Planning and Zoning Commission Meeting

*Case Report –Site Plan Application – Aubrey High School
Planning and Zoning Commission – August 8, 2024
City Council – August 22, 2024*

**SITE PLAN
FOR
AUBREY HIGH SCHOOL
INDOOR PRACTICE FIELD
ADDITIONS/RENOVATIONS
AUBREY INDEPENDENT
SCHOOL DISTRICT**

VARIANCE APPLICATION

VOLUME
Sheet No.
ASO.02

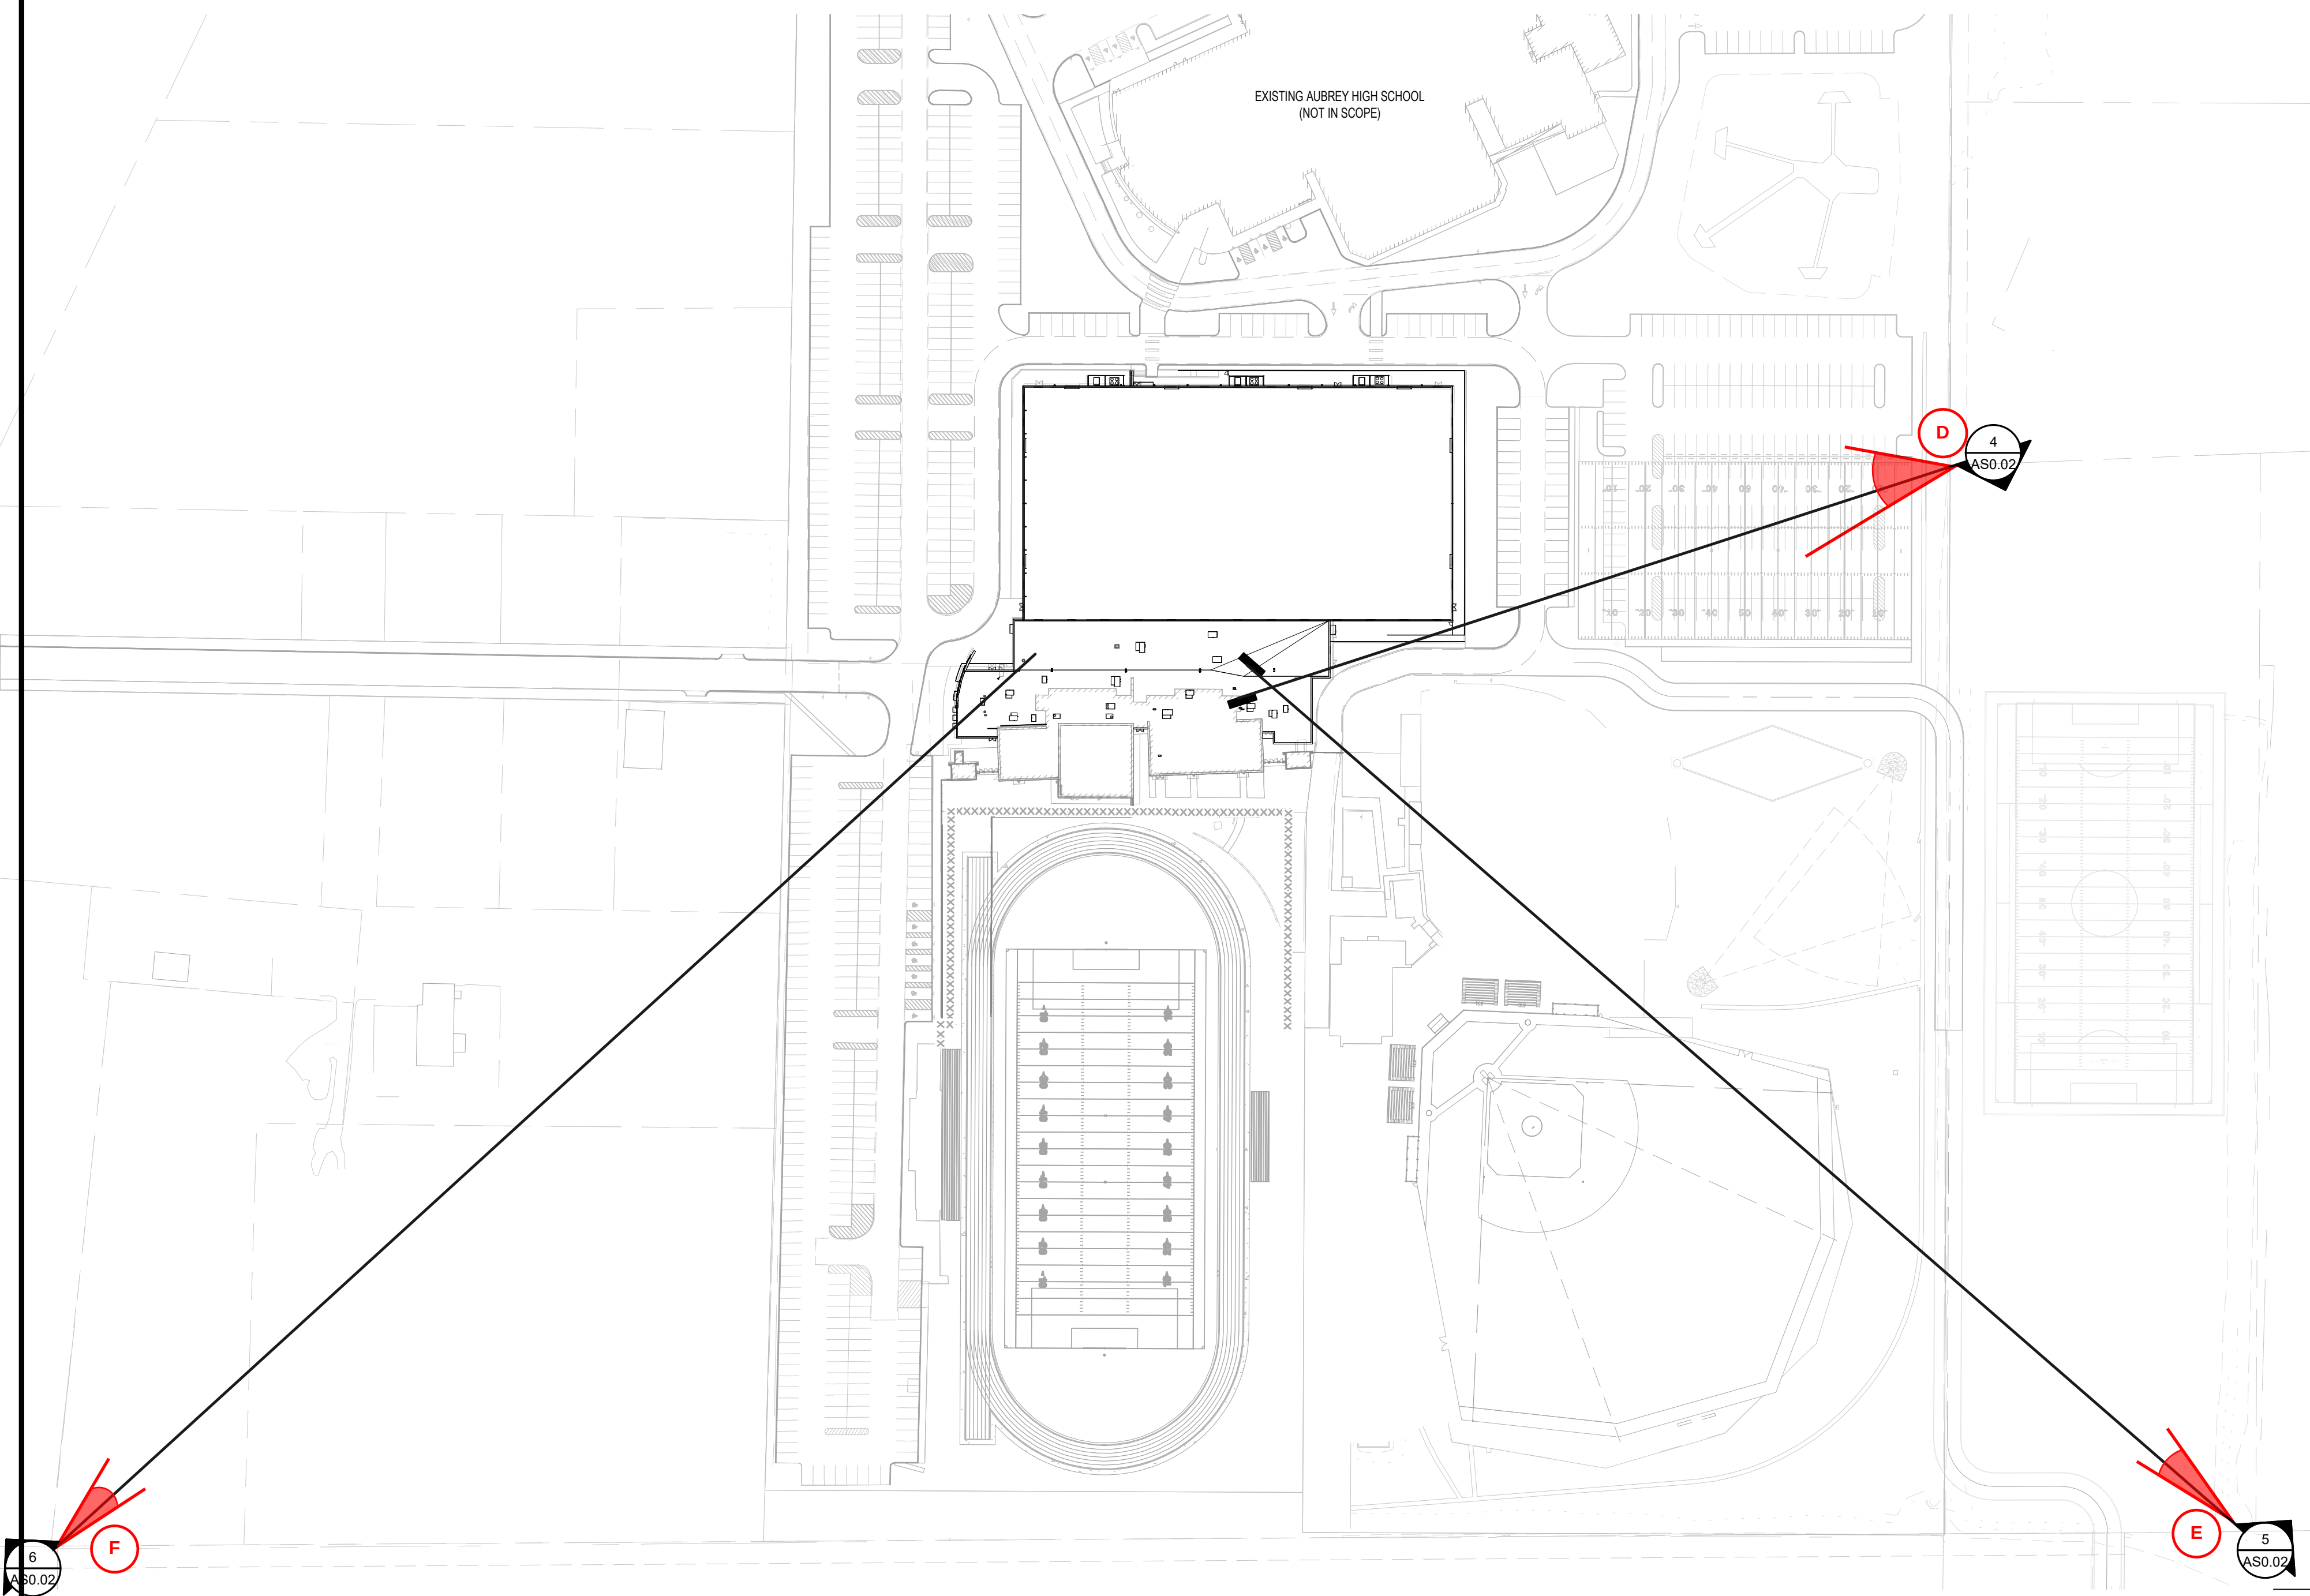
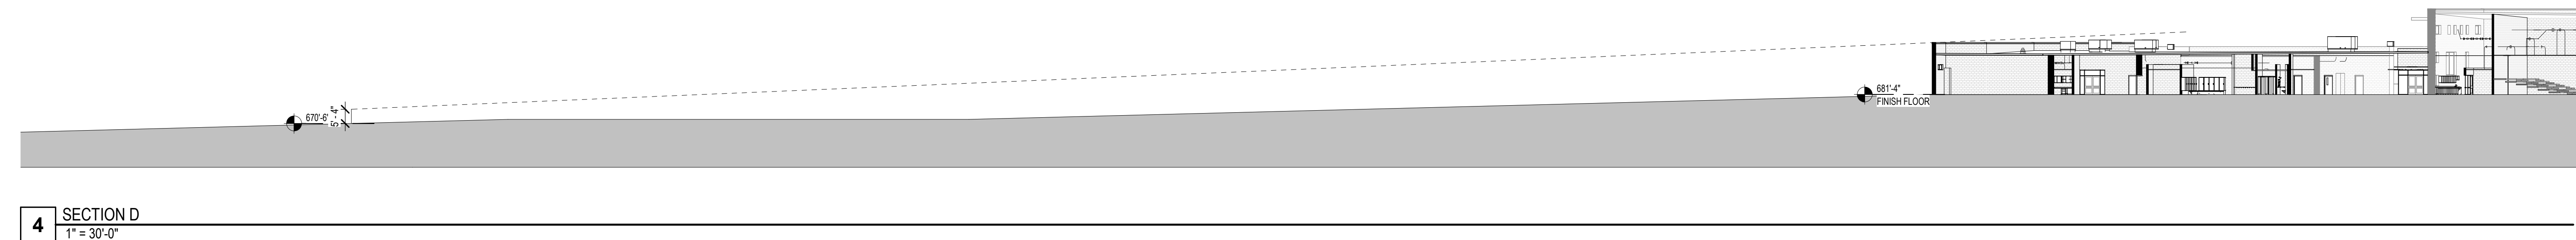
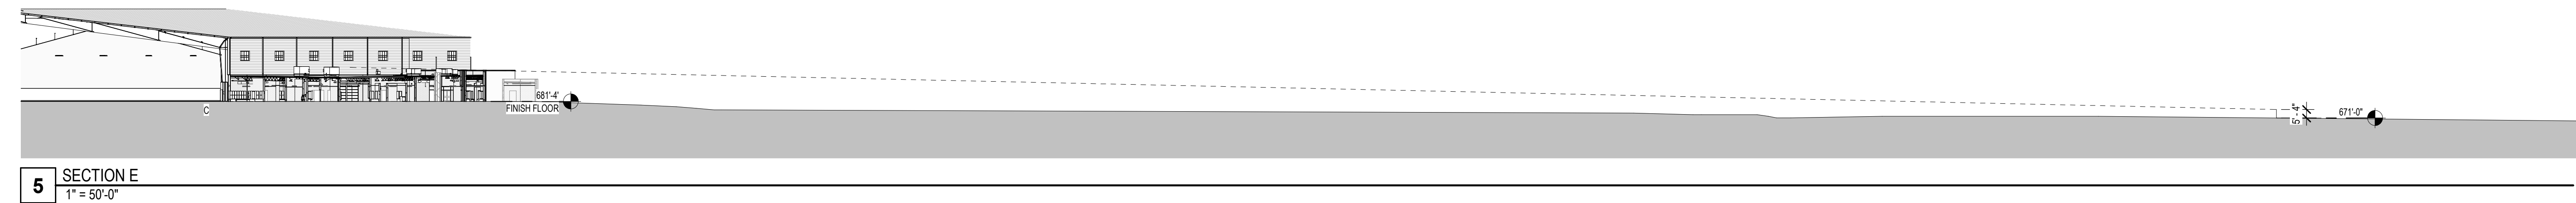
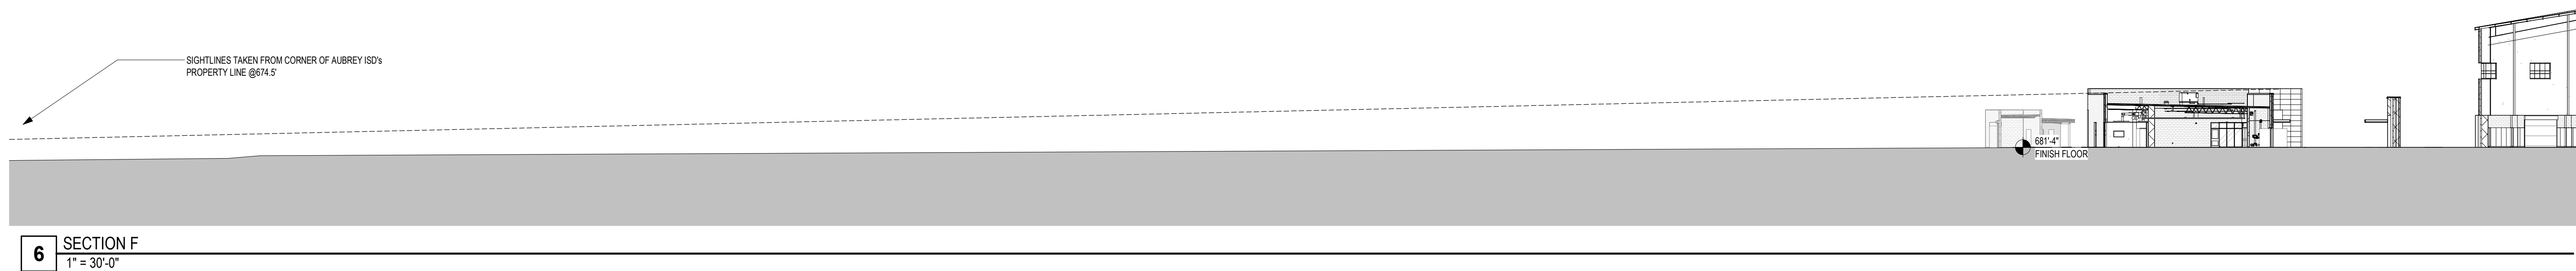
1. Roof Top Mechanical Units: The existing walls on the field house structure’s south elevation are not tall enough to fully screen the equipment. Adding wall height or screening panels onto the roof would be costly and compromise the roof and structure integrity. The new addition meets the requirements of the Code; and
2. Air Rotation Units: The proposed air rotation units for circulating conditioned air are ground units and screening them prohibits the flow of air which is needed for the units to work properly.

The rooftop mechanical on the existing field house is over 700 feet from the southern property boundary.

The ground units on the north side of the new field house addition are over 900 feet from the property line/FM 428 (Spring Hill Road).

Staff reviewed the variance request and supports the hardship findings.

1. Approval of the mechanical screening equipment variances and revision of NOTE #2 to reflect P&Z and Council consideration/approval (if approved);
2. An updated lighting and photometric plan meeting the City’s standards shall be submitted for review; and
3. The Site Plan is in review and approval is subject to subsequent
